Proposed Townhouses and Duplexes
86th St. and 87 St. E.
Bloomington, MN

SHEET TITLE
PROPOSED SITE PLAN

SHEET NO.
A1

1 PROPOSED SITE PLAN
SCALE: 1" = 20'-0"

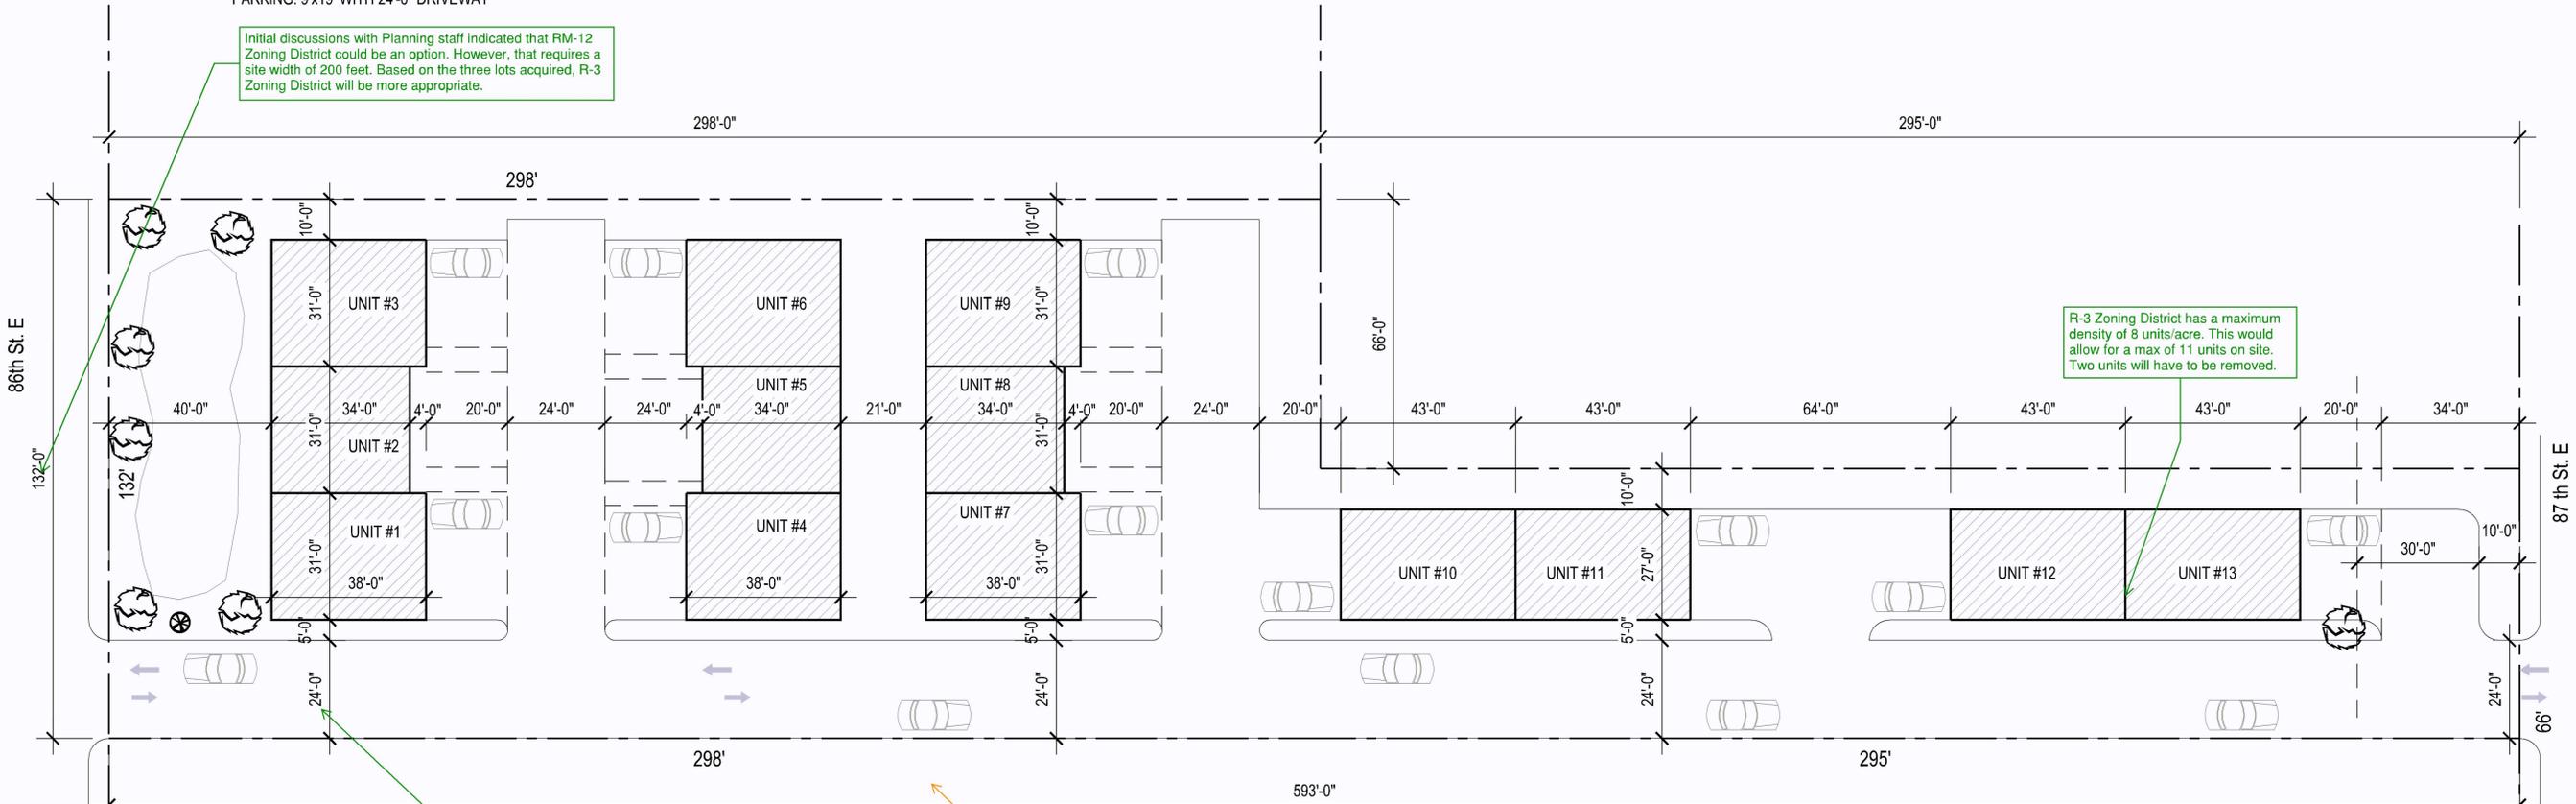
Townhomes with three or more bedrooms must be a minimum of 1,040 sq ft of living space.

Maximum of 70% impervious surface allowed with R-3 Zoning District.

Garage door heights must not exceed 8 feet in height.

Landscaping must meet requirements of 21.301.15. Will require about 24 trees and 59 shrubs on site.

Minimum parking requirements will be based on the number of townhouse units and the number of bedrooms for each unit. See 21.301.06 for parking standards. Driveways greater than 20 feet and garage space can be counted towards parking stalls minimums.

Must meet 2020 MN State Building Code

A SAC fee is required for any new connections to city sewer system per the Metropolitan Council.
On January 2nd, 2025, the City of Bloomington implemented a City SAC charge. The cost will be \$5,000 per City SAC unit. The amount of SAC charged will mirror the MET Council SAC. This applies to any permits submitted on or after 01/02/25.

Initial discussions with Planning staff indicated that RM-12 Zoning District could be an option. However, that requires a site width of 200 feet. Based on the three lots acquired, R-3 Zoning District will be more appropriate.

3 unit townhome configuration will require those units to be sprinklered.

Hydrant coverage shall be provided within 50' of the FDC and within 150' of all portions of the structure.

Building/property shall be adequately signed for emergency response.

A looped water supply feeding a single, combined water service is required for the domestic and sprinkler system water demand.

Emergency vehicle access lane shall support a minimum 40 tons.

R-3 Zoning District has a maximum density of 8 units/acre. This would allow for a max of 11 units on site. Two units will have to be removed.

Structure setbacks in R-3 would be 30 feet from the street, 30 feet from the rear and 10 feet from the side property line.

This two-way drive can be reduced to 20 feet as there is no parking adjacent to the drive aisle.

where is the property line? Show drive aisle setback from property line.

Show locations of neighboring houses - will want to identify vegetation/screening that will be provided on your site to screen headlights from the internal driveways on this site.

Visitor parking

Planning staff are working on code amendments related to "missing middle" housing types, including townhouses. Depending on when the applicant applies for a building permit, some townhouses performance standards could be updated.

Zoning applications would include: Rezoning, Site Plan (FSBP or PDP/FDP), and Type I Plat. This would require review by the Planning Commission and final approval from the City Council.

Maximum height of two stories or 40 feet allowed.
